11-RPS-01

TN # 69988

I am writing to protest against the proposed Narrows Inlet Power project by NI HOODINAH COVEP.

Re: Narrows Inlet Hydro

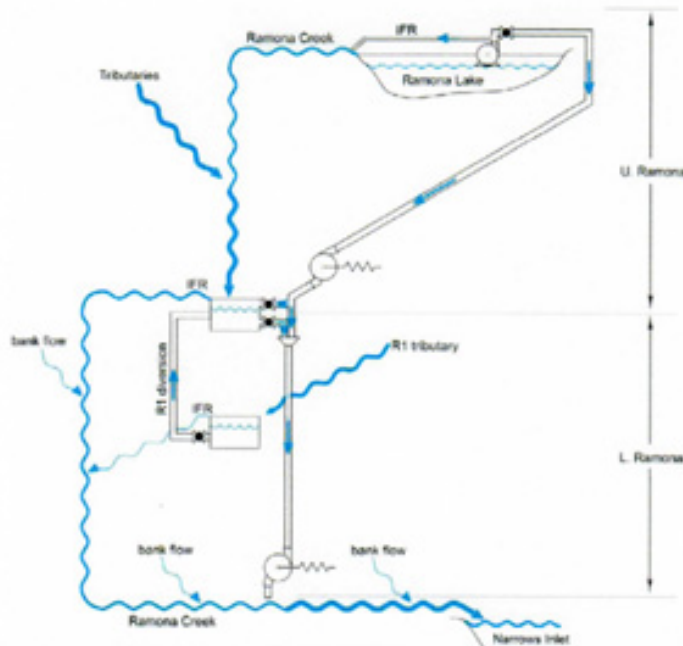
I submitted a .pdf with many of my concerns on Oct 26 at 3:30pm, but since then have noticed yet another possible issue. It appears the Ramona Lake component relies on electric pumps to pump water up over the dam and into a steel holding tank before entering the penstock. There does not appear to be any means to maintain flow in the event of electric pump failure, other than back up diesel pumps. It is conceivable for both systems to fail in adverse alpine weather conditions. This means all flow stops in Ramona. It is not just a case of opening a valve in a pipe or bypassing a turbine if this happens when the lake is drawn down 45m. Simply put, the water can't get out over the dam. If this is true, it goes directly against consultant Dave Bates recommendation to have a maintenance free IFR (minimum stream flow) system such that there is no chance of the river running dry because of equipment malfunction. If this is true it also means all (or a good part of) the water now sits in a steel tank first before coming down the mountain? Even the drinking

water? This couldn't be the design....could it? At minimum it proves the system is very complicated and relies totally on controls and electronics that are remotely monitored. Not a good idea with people below.
